REQUEST FOR INFORMATION

DATE: October 06, 2016 **NO.:** RFI-316

Project Name: 15051-Webster University Interdisciplinary Science Building Project No.: 15051

Subject: Electrical panel conflict with steel

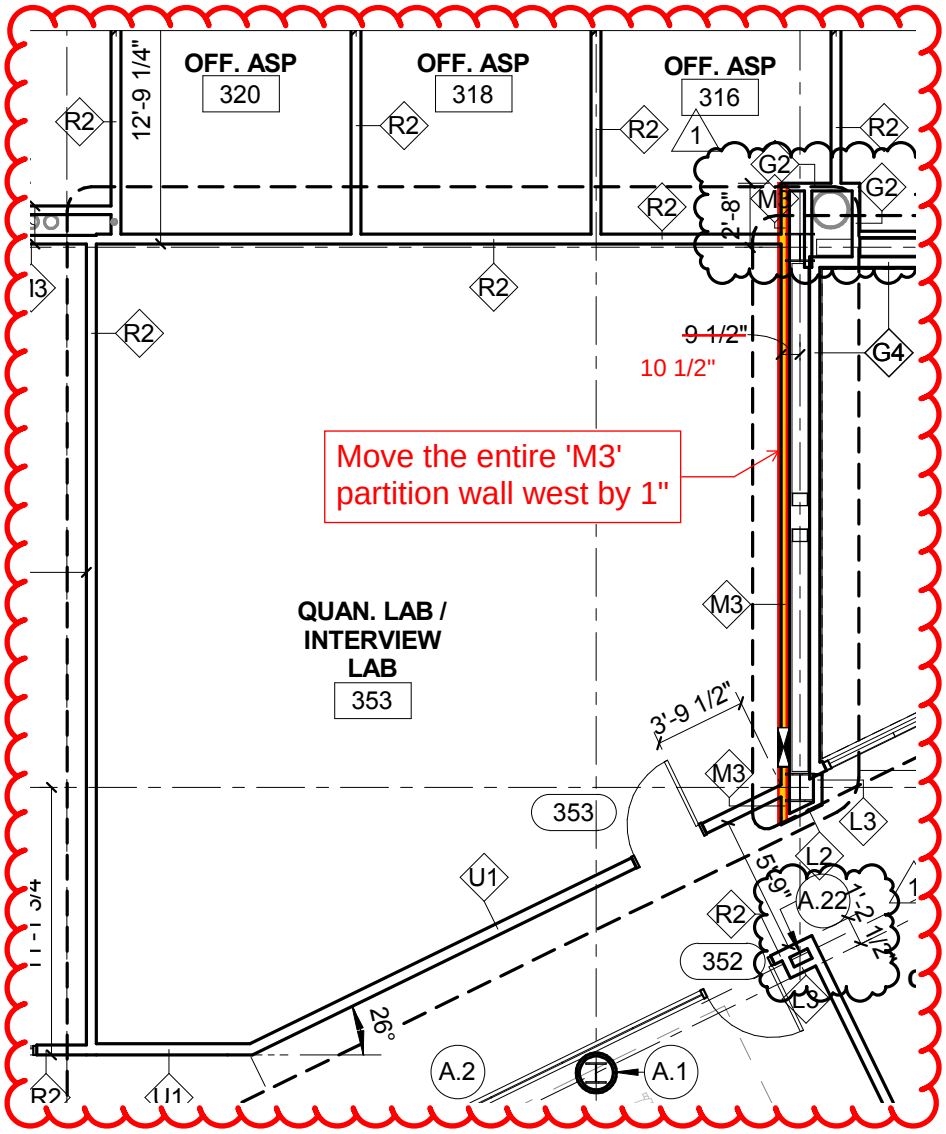
Electrical panel 3LL5 conflicts with the steel (see screenshots) in room 353 as shown. Can the panel move north along the wall or can the wall be furred out to accomodate?

Move the entire 'M3' partition wall west by 1" (see attached sketch) to accommodate the electric panel.

OFF. ASP
320
OFF. ASP
318
OFF. ASP
316
12'-9 1/4"
R2
G2
M3
G4
9 1/2"
10 1/2"
Move the entire 'M3' partition wall west by 1"
QUAN. LAB / INTERVIEW LAB
353
3'-9 1/2"
L3
L2
U1
26°
A.2
A.1
A.22
352
